ENGINEER'S ADDENDUM NO. 01
TO THE BID DOCUMENTS (PLANS AND SPECIFICATIONS) FOR
Beaver Creek Clean River Project Phase III – Beaver Creek Diversion Tunnel
AWB Contract # 3-G
City of Albany
Albany County, New York
October 14, 2020

C-101 – WORKING SHAFT SUPPORT OF EXCAVATION DESIGN REQUIREMENTS

C-102 – TUNNEL/PIPE PLAN AND PROFILE

BEAVER CREEK CLEAN RIVER PROJECT
PHASE III - BEAVER CREEK DIVERSION TUNNEL

30" DIVERSION PIPE PROFILE
SCALE: H: 1"=60' V: 1"=20'

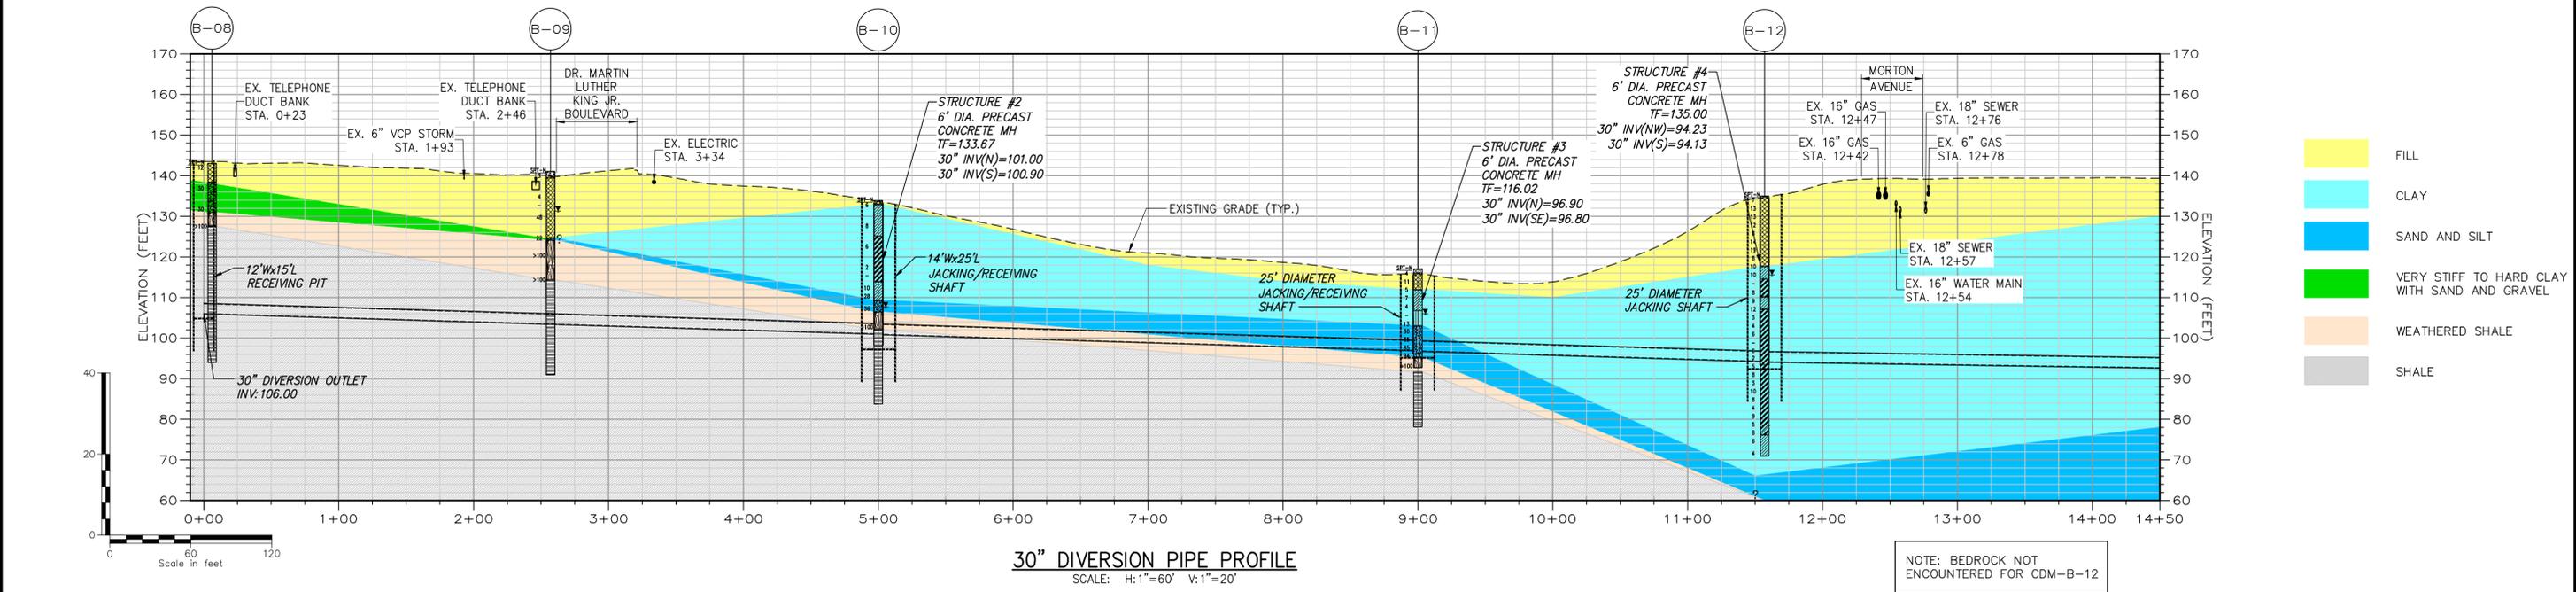
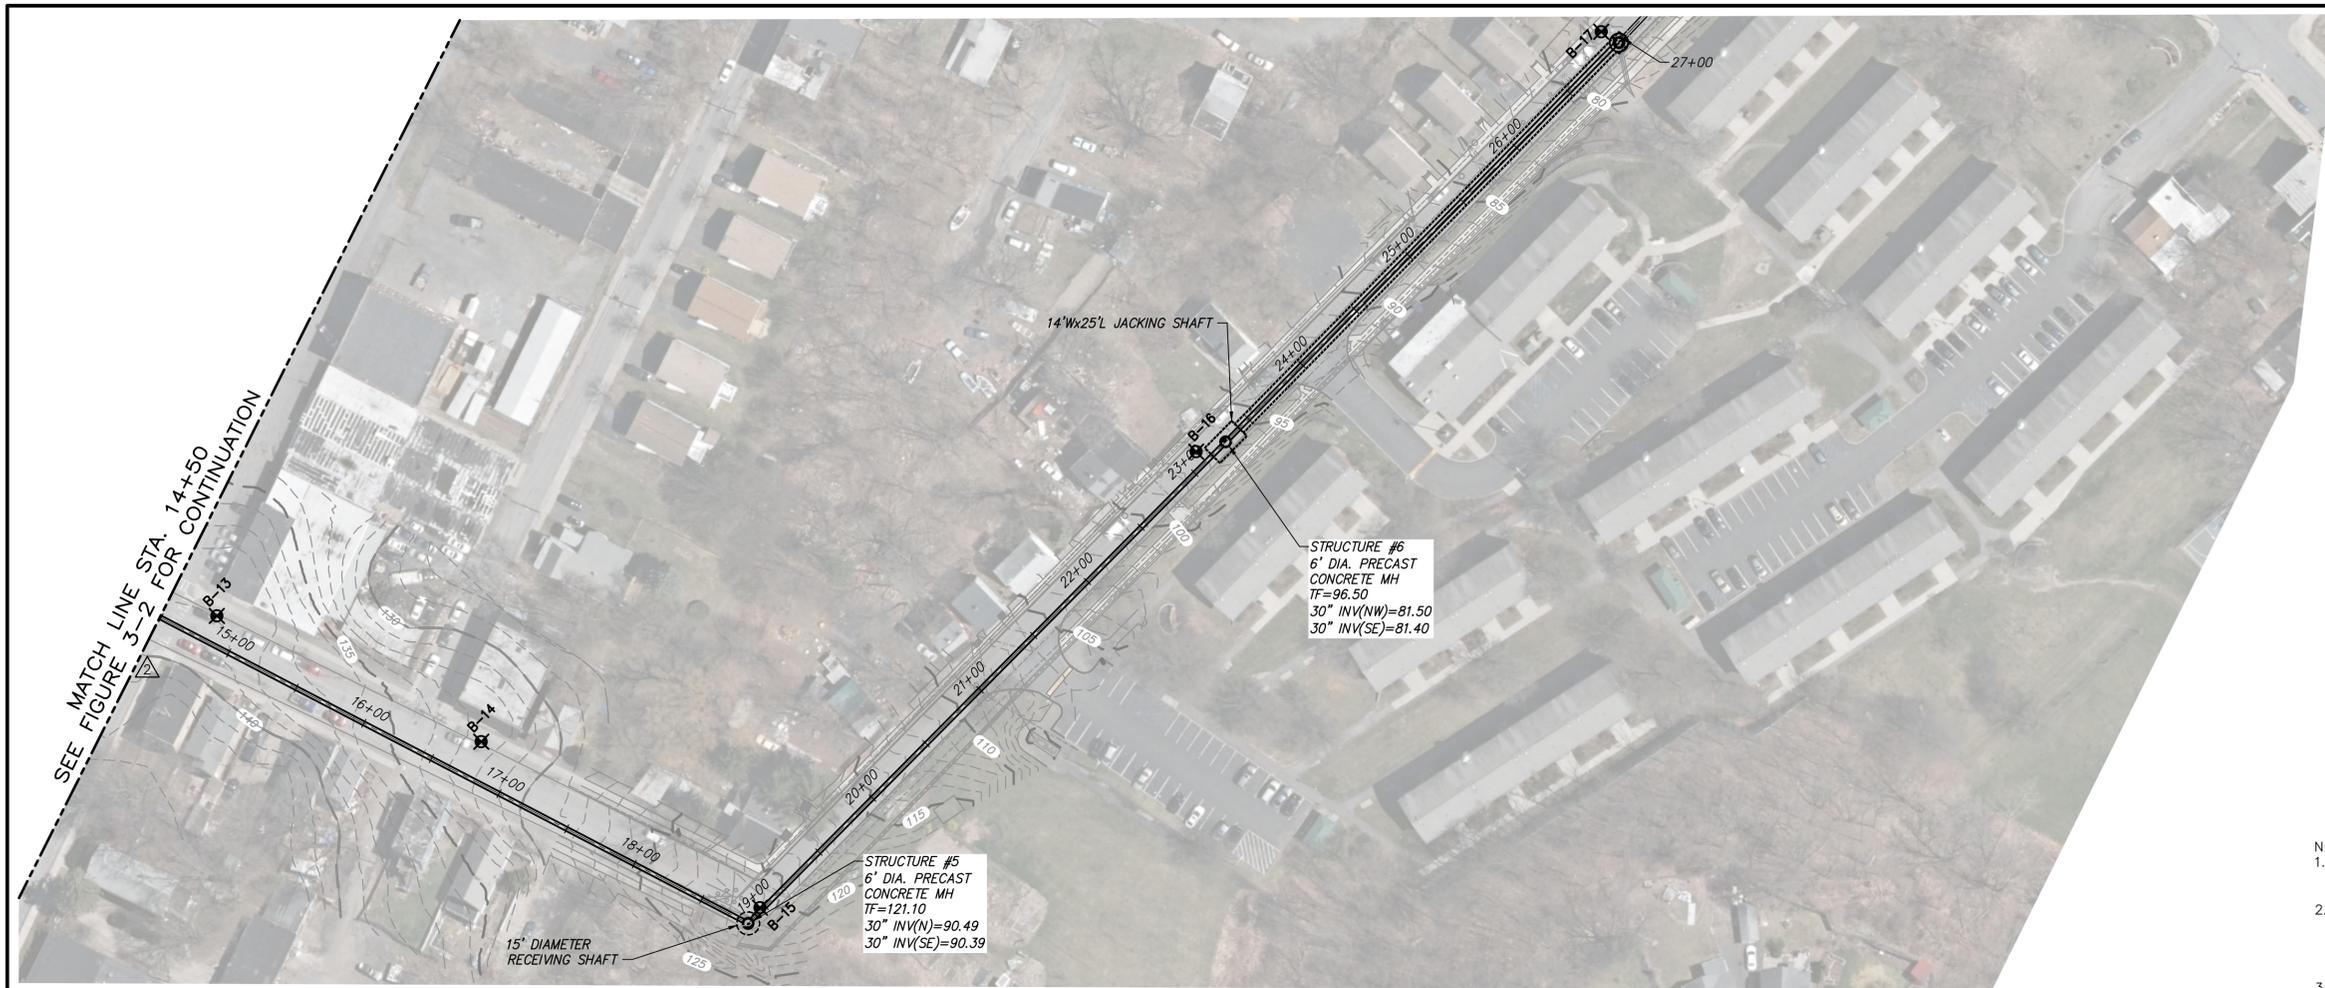
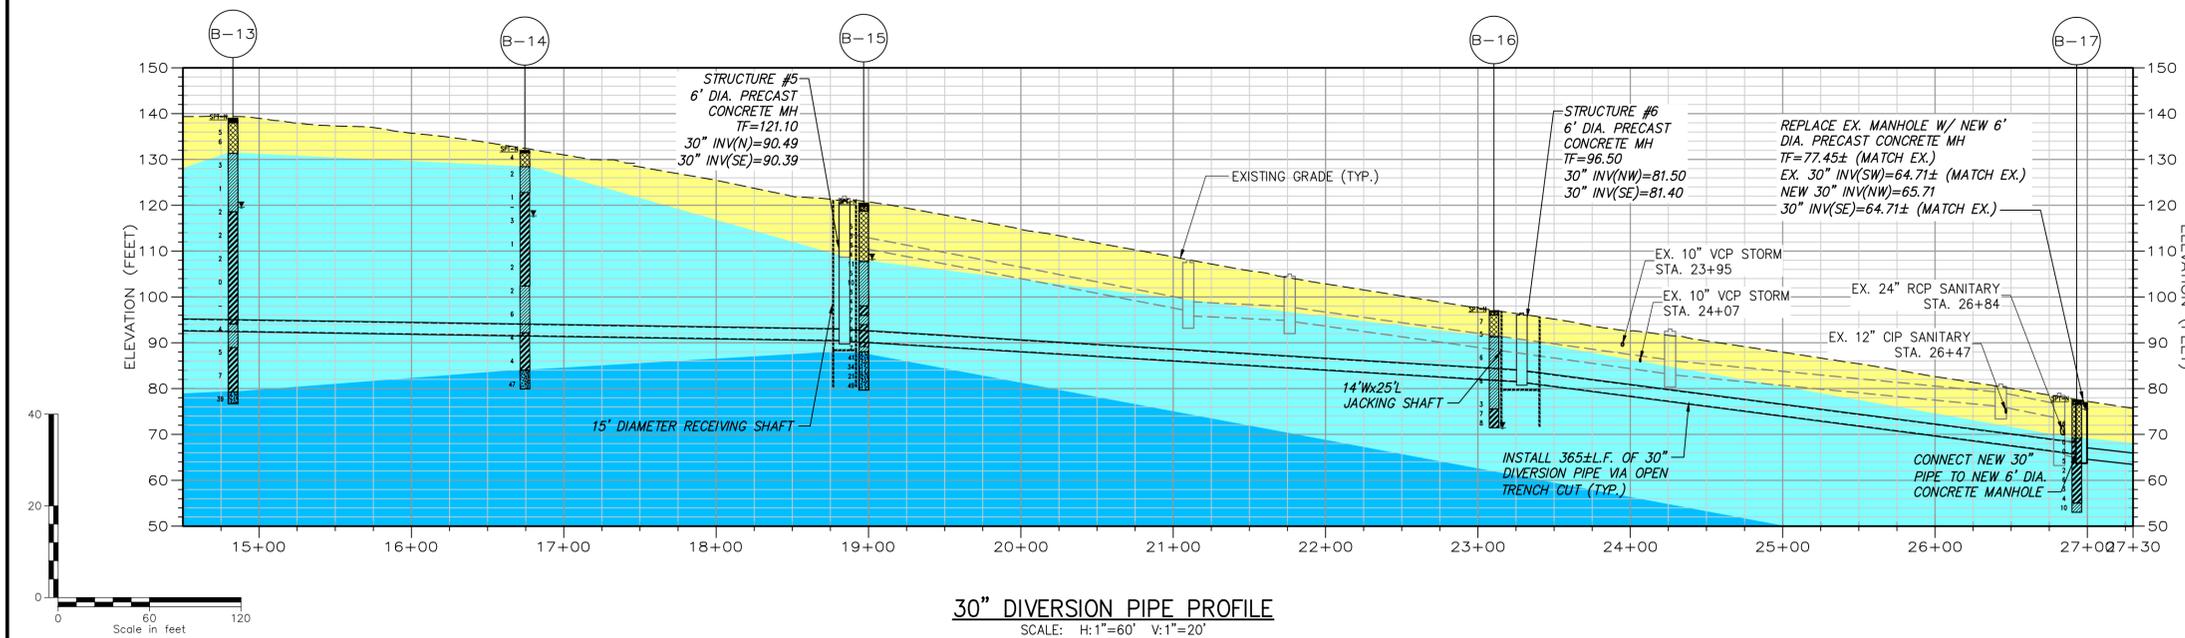
15. Missing Figure 3-3 added.

23. Figure 3-2 updated and included as part of the GBR document. See separate attached figure that show clouds where the modifications were made.
 24. Figure 3-3 updated and included as part of the GBR document. See separate attached figure that show clouds where the modifications were made.

**Stickiness/Clogging Potential
 Figure 3-8**

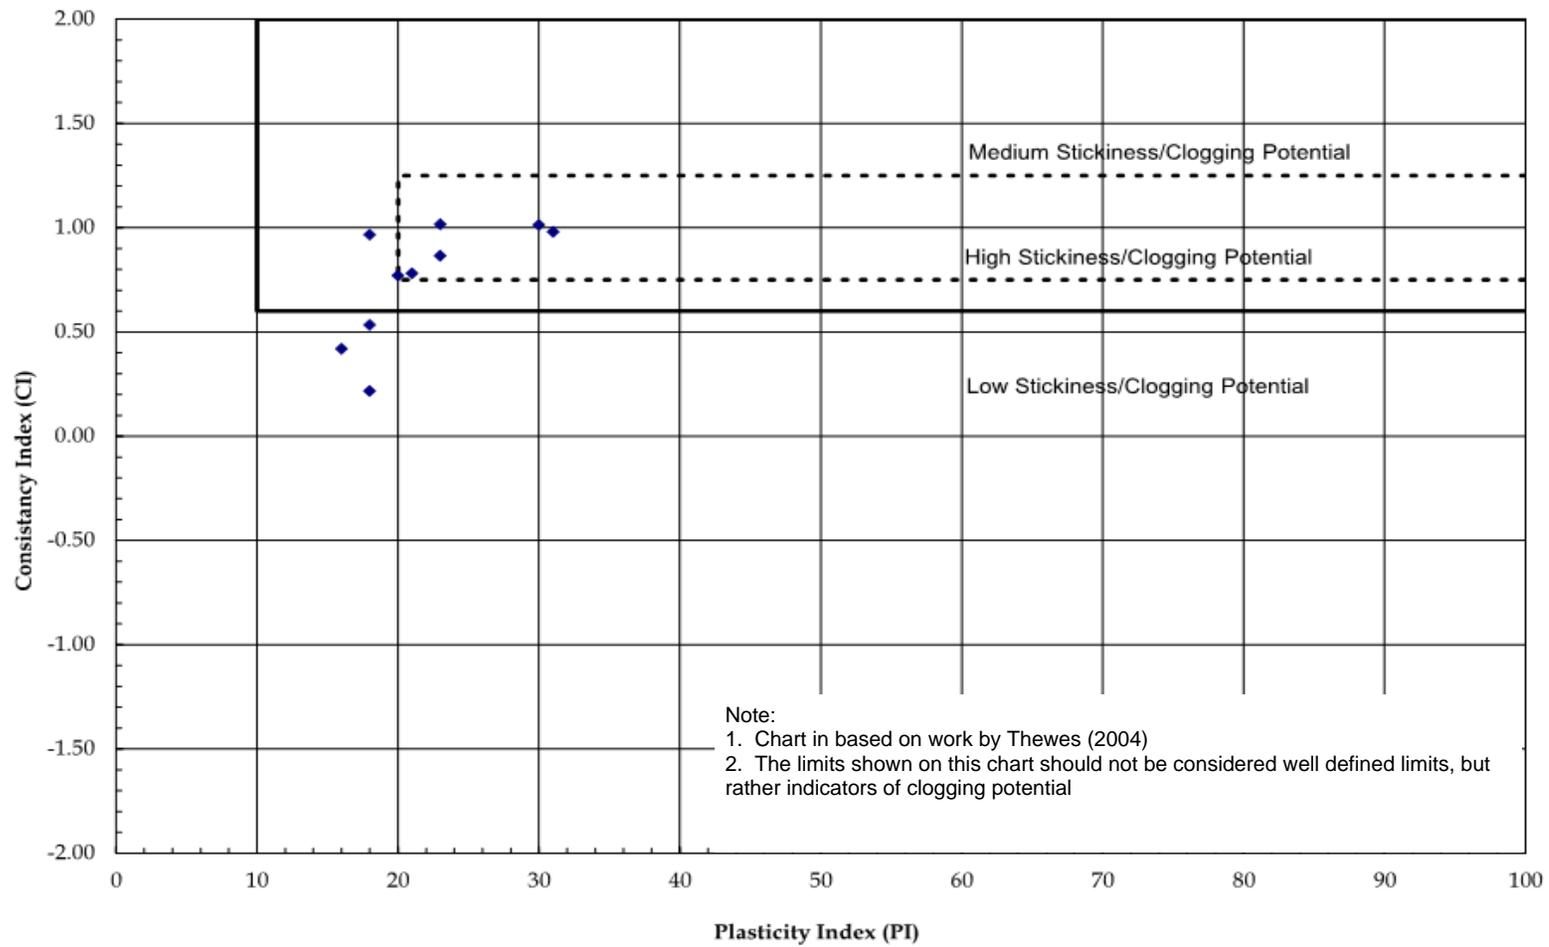
14. Figure 3-8, Note 1 deleted; Notes 2 and 3 renumbered to Notes 1 and 2.
